ZedBoard Rev C.1 Errata

Figure 3 - Identifying affected ZedBoards

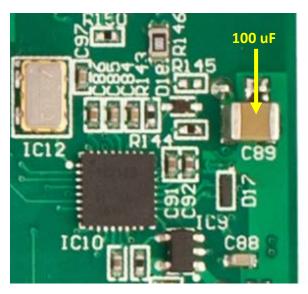
The first ~5000 Rev C ZedBoards populated a 100uF capacitor at location C89, although the schematics show 120uF. C89 is used as the TUSB1210 Cvbus when jumper JP3 is installed. JP3 is installed when the user desires to put the ZedBoard in Host USB mode.

According to Table 8-2 in the TUSB1210 datasheet for VBUS – HOST, Cvbus should be larger than 120uF.

Replace C89 with a capacitor that is 120uF or larger.

Figure 4 – ZedBoard with Heatsink and Auxiliary Fan attached

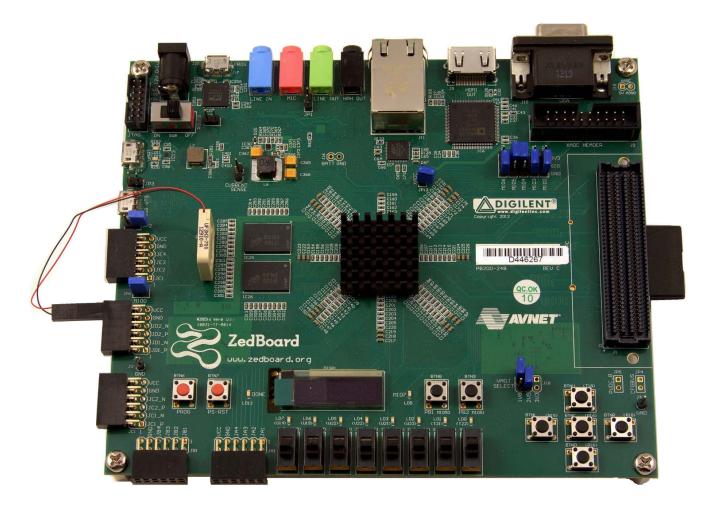
Designs that exercise the Zynq on the ZedBoard at the highest performance (especially FMC card applications) or high ambient temperatures may experience a heat-related failure. Similar applications may not fail on the ZC702, which has the same 7z020 device.

The Rev C ZedBoard ships with a Commercial temperature grade Zynq device. According to the Zynq datasheet, the maximum operating junction temperature is specified at 85° C. When the junction temperature exceeds 85° C, the Zynq device may experience failures.

A heatsink applied to the ZedBoard's Zynq device is recommended for all applications. Starting in October 2012, all ZedBoard's are populated with a CTS BDN09-3CB/A01. Additionally, the most demanding applications will benefit from a fan to produce airflow over the ZedBoard. For example, the Zynq-7000 SoC/Analog Devices Software-Defined Radio Kit will ship with Sunon fan UF3H3-700, which can be operated from 3.3V power available through one of the Pmod connectors.

Both the heatsink and the fan are listed on the **ZedBoard Accessories** page.
